**RE: Addendum to the Contract Documents for the Argo Dam and Geddes Dam Coating and Miscellaneous Repairs
Bid No. ITB-4261**

**ADDENDUM NO. 1
TO
BID DOCUMENTS
FOR
ARGO DAM AND GEDDES DAM
COATING AND MISCELLANEOUS REPAIRS
FOR THE
CITY OF ANN ARBOR, MICHIGAN**

Title
ARGO DAM
SITE WORK

Drawing No. 1C-102

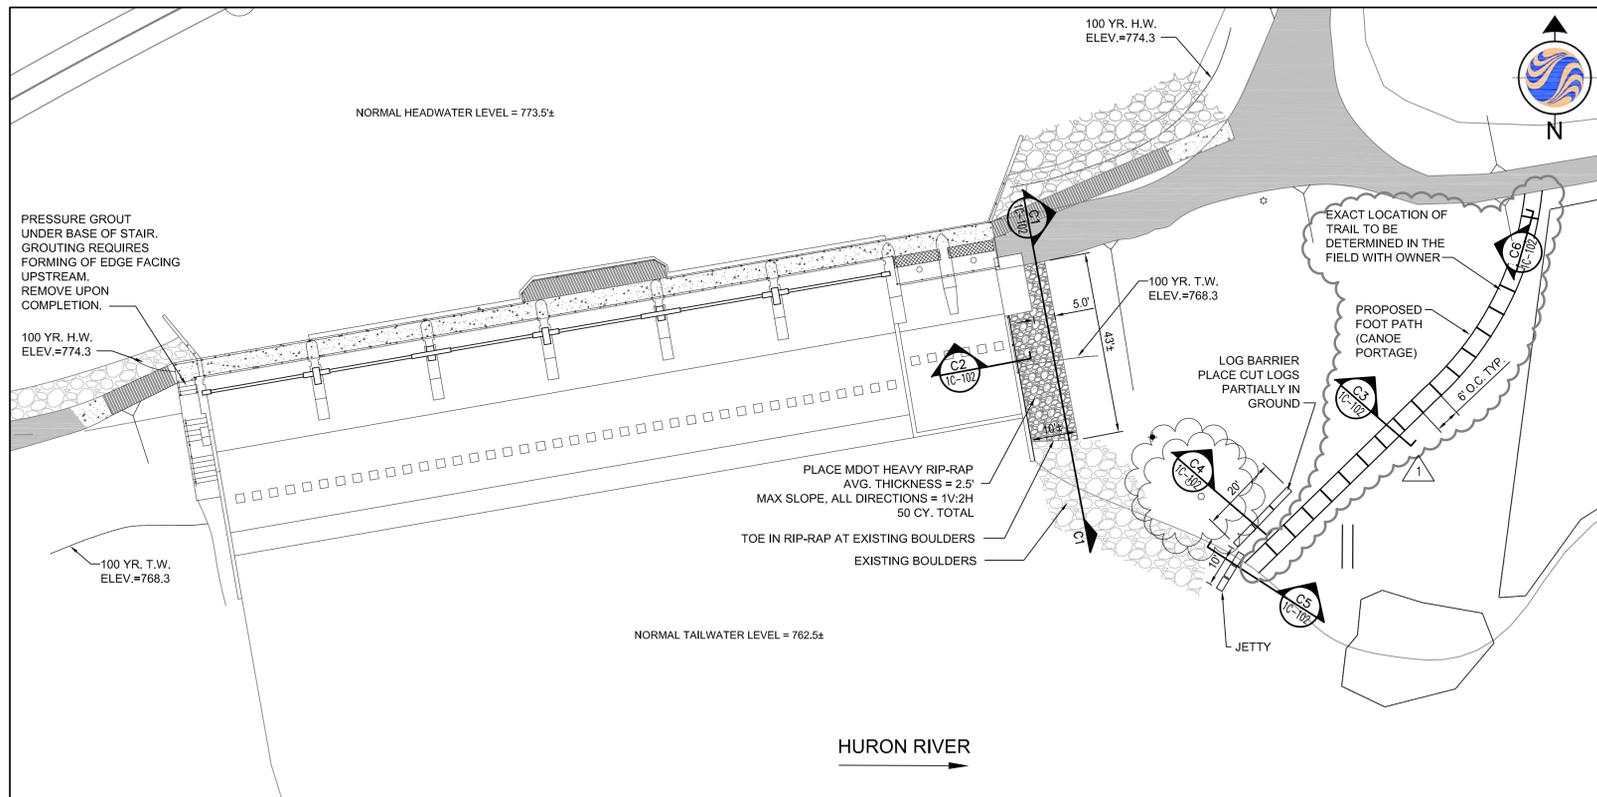
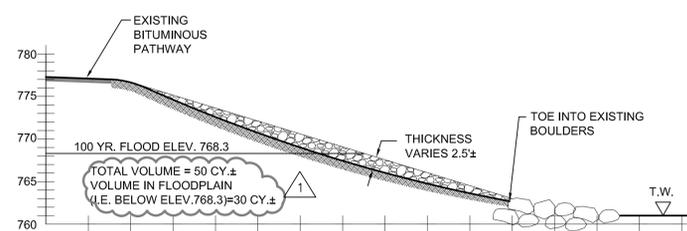
- Q:** Drawing 1C-102 Section C1 indicates 110 CY of rip rap at the Argo site, while the plan view on this page and the bid form show 50 CY. Which is correct?
- A:** **The correct quantity is 50 CY.**
